SUBJECT: Donald C. Cook Nuclear Plant Unit 2
Docket No. 50-316
Exigent License Amendment Request Regarding Containment Distributed Ignition System

Proposed Exigent License Amendment Request Regarding Containment Distributed Ignition System

DONALD C. COOK NUCLEAR PLANT UNIT 2 TECHNICAL SPECIFICATION PAGES
MARKED TO SHOW CHANGES

Figure 1
Unit 2 - Train B Lower Wiring Diagram

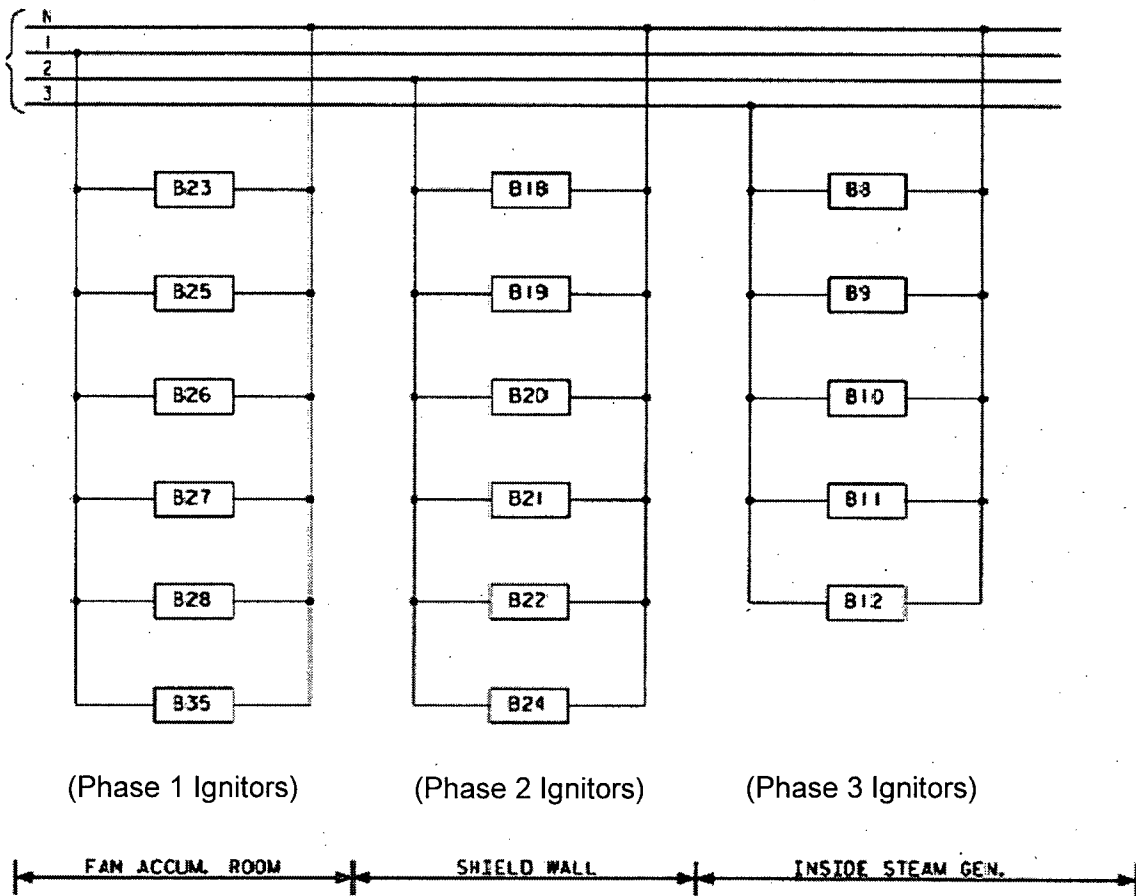
When TS Surveillance Requirement 3.6.9.1 was performed on January 14, 2010, acceptable current readings were obtained for all Train A upper and lower ignitors, all Train B upper ignitors, and the Train B lower ignitor string powered by phase 1. However, low current readings were obtained for the Train B lower ignitor strings powered by phase 2 and phase 3. The readings indicated that one ignitor in the string powered by phase 2 and one ignitor in the string powered by phase 3 had failed. Radiation and high temperature hazards precluded access that would allow visual observation or repair of all Train B lower ignitors in strings powered by phase 2 or phase 3, except for phase 2 ignitor B24. During troubleshooting, the glow plug for ignitor B24 (accumulator room 1) was observed to be glowing when energized, indicating that it was operable. Therefore, one ignitor (B18, B19, B20, B21, or B22) in the lower containment string powered by phase 2 is considered to have failed, and one ignitor (B8, B9, B10, B11, or B12) in the lower containment string powered by phase 3 is considered to have

With two DIS Train B ignitors inoperable, the number of operable ignitors in Train B is less than the minimum of 34 ignitors required by TS Surveillance Requirement 3.6.9.1. Therefore, LCO 3.6.9 Condition A was entered. The Required Action for this Condition is to restore the inoperable DIS train to operable status within 7 days or perform TS Surveillance Requirement 3.6.9.1 on the operable DIS train at least once per 7 days. Since these ignitors cannot be repaired with the unit operating in Mode 1, I&M is performing TS Surveillance Requirement 3.6.9.1 on DIS Train A weekly.

Footnote: For the remainder of Fuel Cycle 18, or until the next entry into a MODE which allows replacement of the affected ignitors, DIS Train B may be considered OPERABLE with one lower containment phase 2 Power Supply ignitor inoperable and with one lower containment phase 3 Power Supply ignitor inoperable.

Figure 2
Unit 2 - Containment Elevation 648 feet and Below
The approximate locations of the Train B ignitor strings powered by lower containment phase 2 are indicated by arrows.

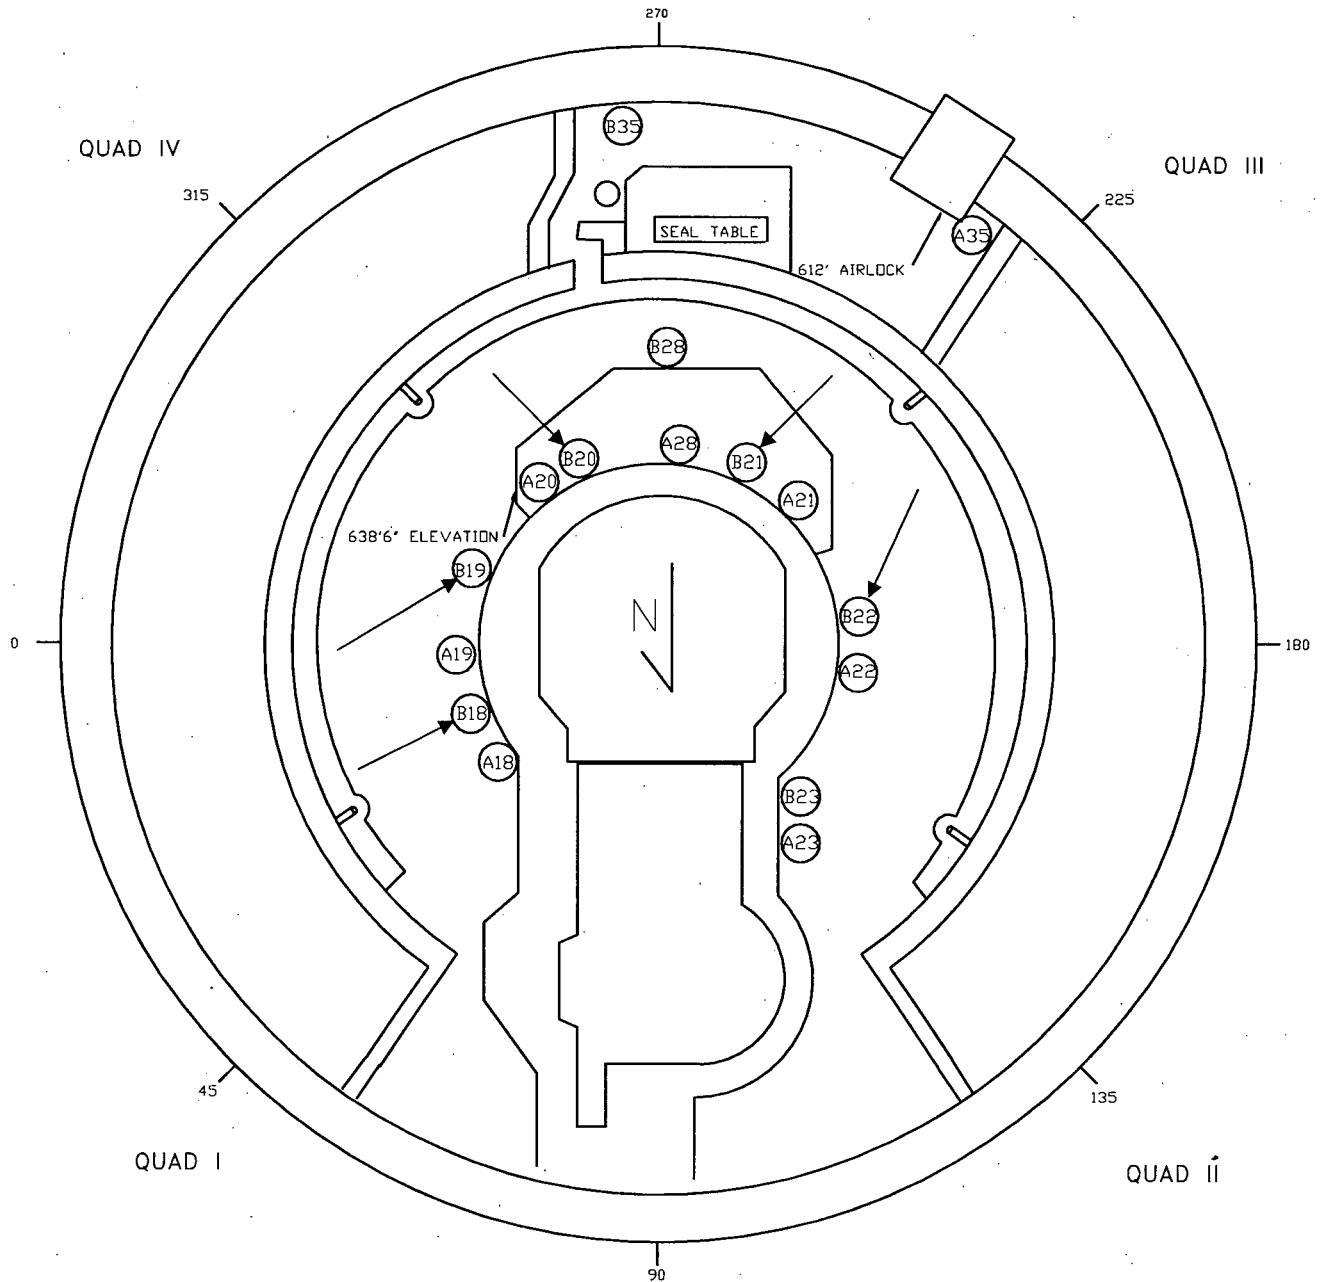
supply phase. The ignitors are located such that each containment region has at least two ignitors, one from each train, controlled and powered redundantly so that ignition would occur in each region even if one train failed to energize. The containment regions and their associated ignitors are listed in Table 2 in this enclosure. The containment locations of the ignitors involved in this amendment request are shown in Figures 2 and 3 in this enclosure.

With the two ignitors out of service, the remaining ignitors provide sufficient capability to burn hydrogen such that the concentration of hydrogen in containment would remain low and the DIS function would be maintained. The remaining 33 ignitors are fully operable and capable of providing the required coverage to effect hydrogen ignition in the event of a severe accident causing fuel damage. Specifically, even with one lower Train B Phase 2 ignitor failed, operation of the remaining operable ignitors in the general area would compensate and burn off any accumulated hydrogen safely because of the well-mixed atmosphere maintained by the CEQ System fans. Similarly, for one failed lower Train B Phase 3 ignitor in a steam generator or pressurizer enclosure, any hydrogen accumulated in the general area would be burned off by operation of the remaining operable ignitors in the area below the enclosure. For a steam generator enclosure, the ignitor in its connected steam generator enclosure would also be available to assure ignition in the shared space; for the pressurizer enclosure, the CEQ System fans assure a rapid volumetric turn-over (approximately once per 5 minutes) of the contained atmosphere so pressurizer enclosure hydrogen concentration would be expected to be similar to that in the area below the enclosure which is protected by fully operational ignitors.
